UNITED STATES PATENT AND TRADEMARK OFFICE

APPLICATION NO.	FILING DATE	FIRST NAMED INVENTOR	ATTORNEY DOCKET NO.	CONFIRMATION NO.
10/534,092	01/13/2006	Michel Garnier	0517-1053	2418

Office Action Summary

GARNIER, MICHEL

ATTACHMENT

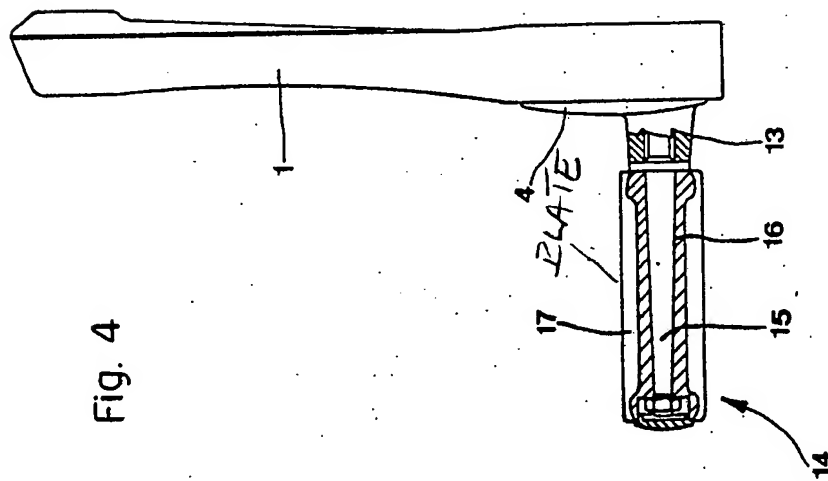
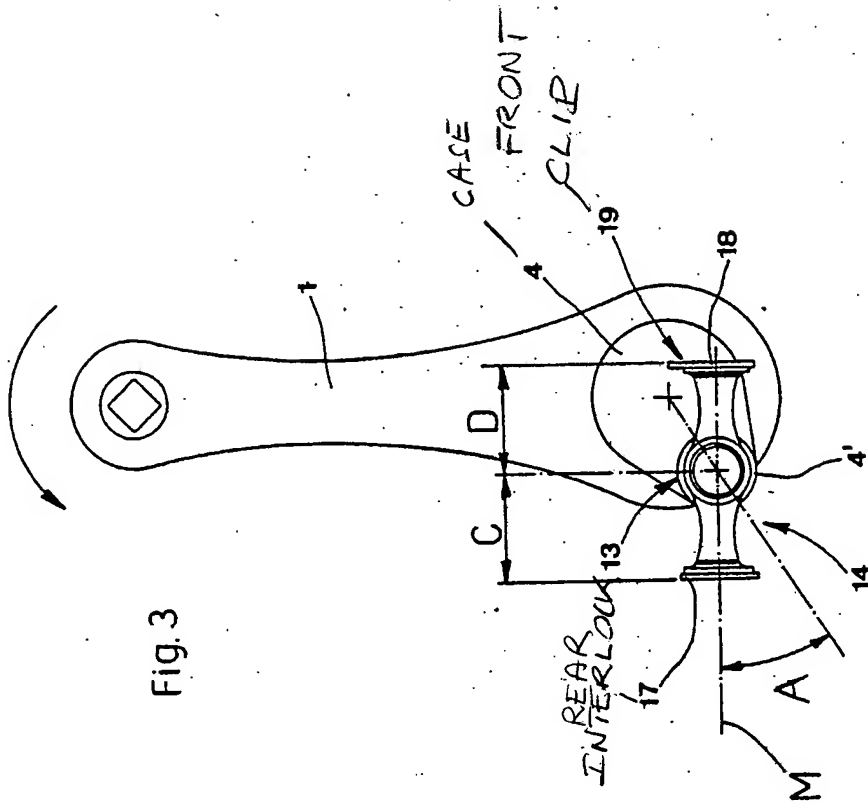
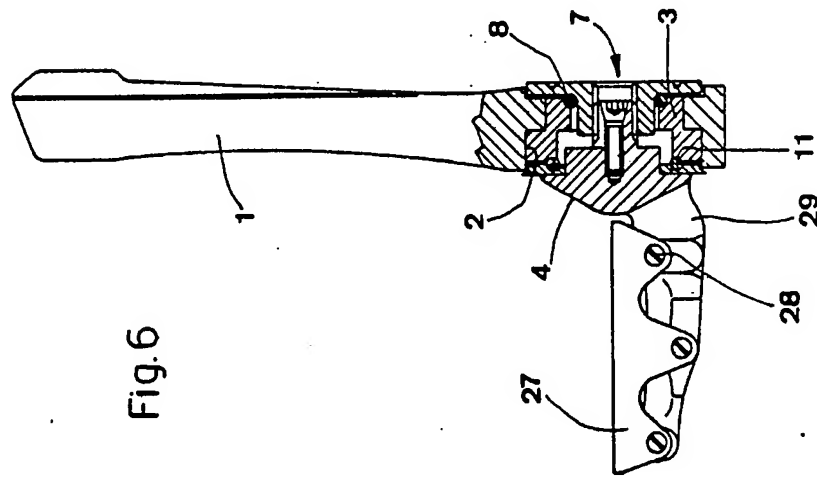
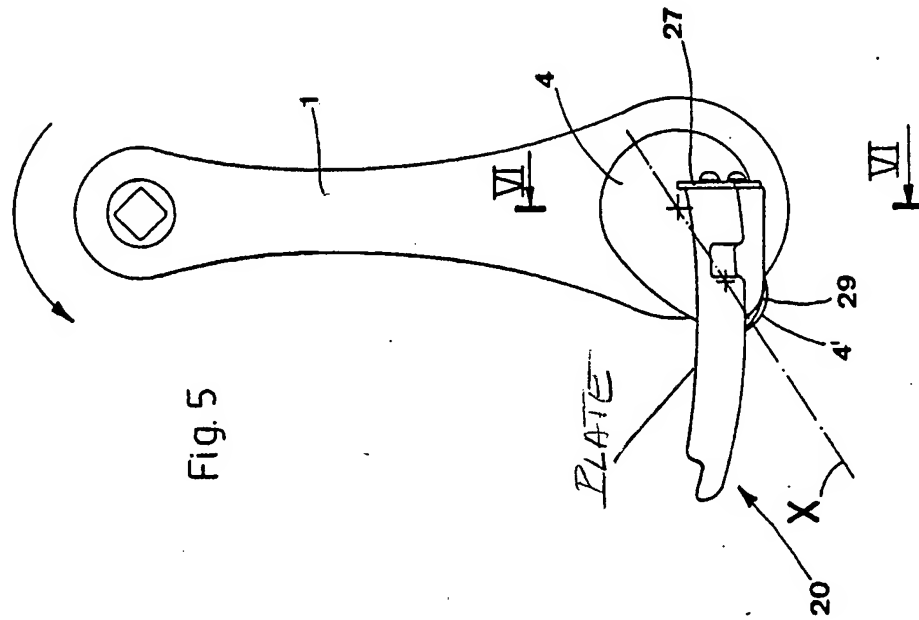
Giorgio teaches a cycle pedal comprising a pedal body 14 or 20 constituted of a *globally* rectangular horizontal plate 17, 18 or 21 (see Attachment hereinafter “Att.”) fitted on its upper surface with means 19 or 27 for locking a cyclist's shoe and on one of its longitudinal edges, a case 4 containing a pedal pin 7 designed to be fixed to the free end of a crank 1 characterized in that the plate 17, 18 or 21 is secured to the case 4 so that its upper surface extends beneath the pedal pin 7 along a distance E (FIGS. 1 and 2) and the support axis of the shoe (not shown) on the

pedal plate 17, 18 or 21 which merges with the front plate capable of passing through the metatarsus of the cyclist's big toe when the latter is pedaling, extends in front of the pedal pin 7 along a distance C, D (FIG. 3) so that the pedal support axis 7 describes a circular curve with centre (unnumbered in FIG. 8) and radius (FIG. 8) offset from downward and from forward relative to the circular curve (FIG. 8) of the pedal pin 7 with centre O (FIG. 8 of Att.), where O' (FIG. 8 of Att.) is the axis of the cycle bottom bracket shell and of radius r and in that the means for locking 19 or 27 comprise, on one hand, a front interlocking mechanism 18 (FIG. 3) or unnumbered in FIG. 10 (Att.) designed to co-operate with the front part of a clip integral with the sole of the cyclist's shoe and, on the other hand, a *movable* rear interlocking mechanism 17 (FIG. 3), 27 (FIG. 10) designed to co-operate with the rear part of the clip of the shoe, the *movable* rear interlocking mechanism 17, 27 being *movable* under the pressure of the rear part of the clip of the shoe from a position called interlocked, and passing through an open position allowing to insert or remove the rear part of the clip of the shoe, until returning to the interlocking position under stress from an elastic means.
